NOTICE OF DECISION

PARTITION / SITE PLAN REVIEW PAR-SPR19-14

APPLICATION NO. : 19-113180-LD / 19-113188-RP

LOCATION: 3770 Fairview Industrial Dr. SE / 97302

PARTITION TENTATIVE PLAN
3770 FAIRVIEW INDUSTRIAL DR SE
SEC 2 T8S R3W W.M.

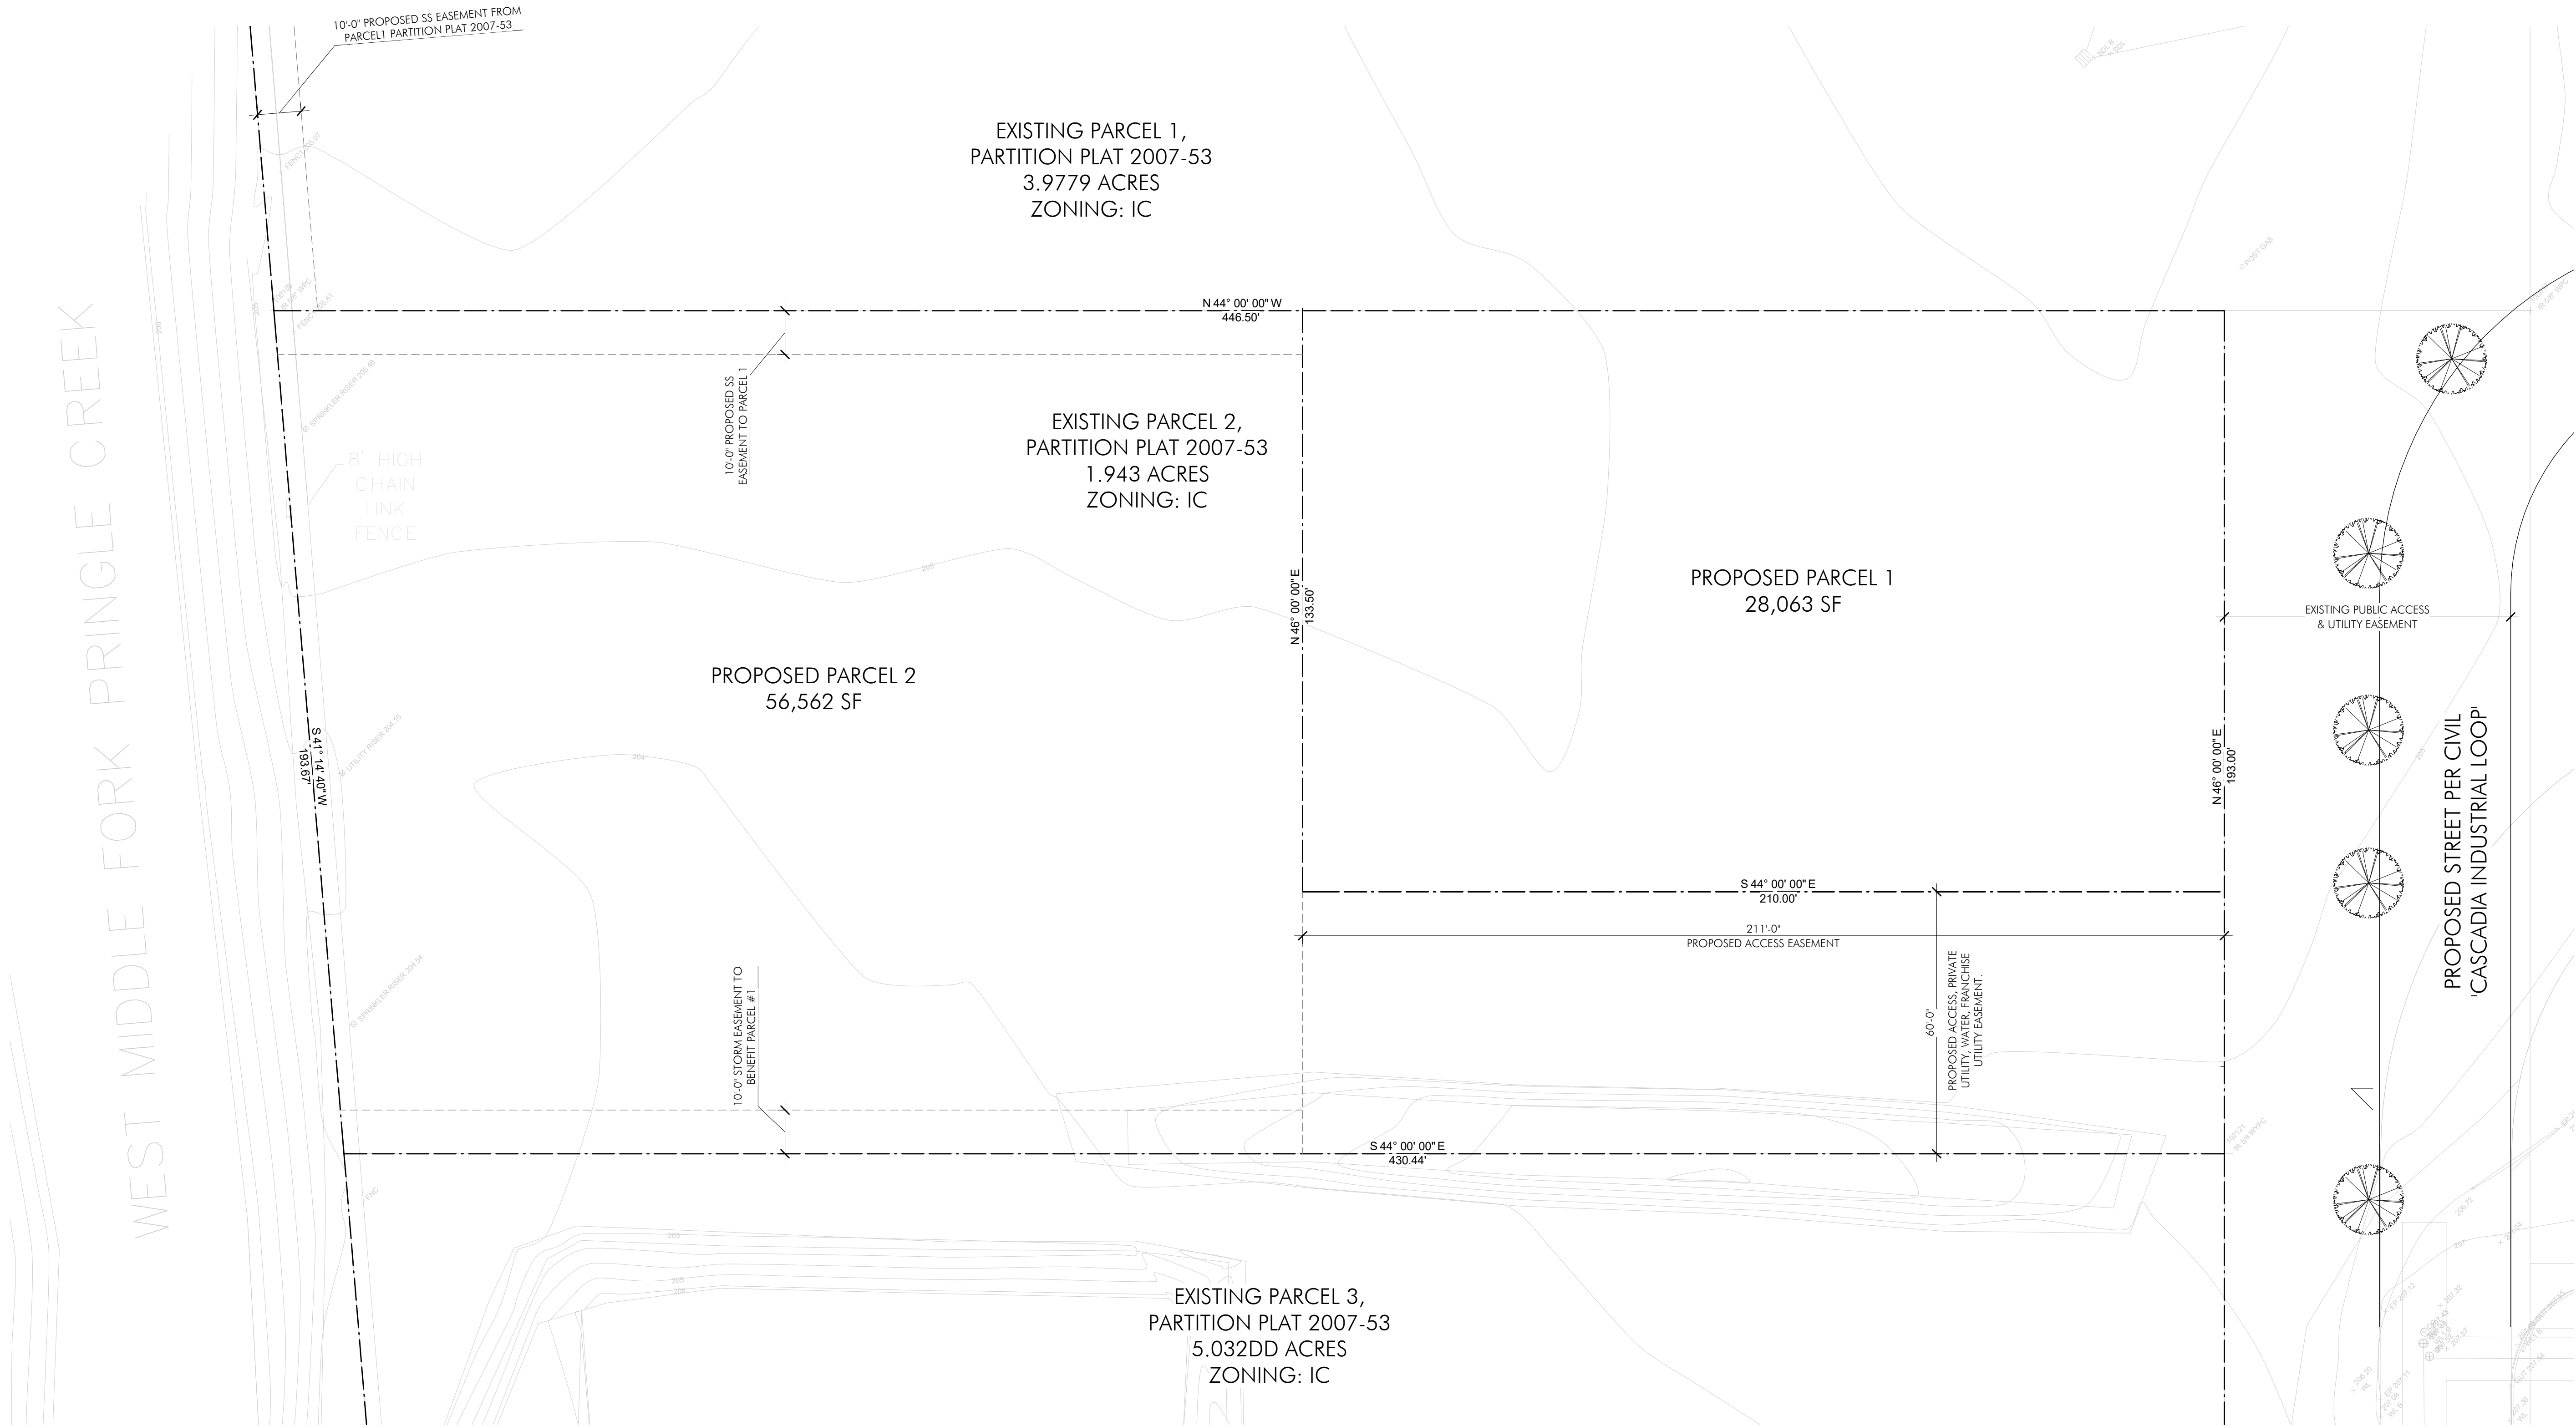
The proposed flag lot accessway serving both parcels is 60 feet in total width and 211 feet in length on the partition plan (**Attachment B**), and the site plan

Condition 2: As a condition of plat approval, the flag lot accessway shall be paved to a minimum width of 20 feet in width.
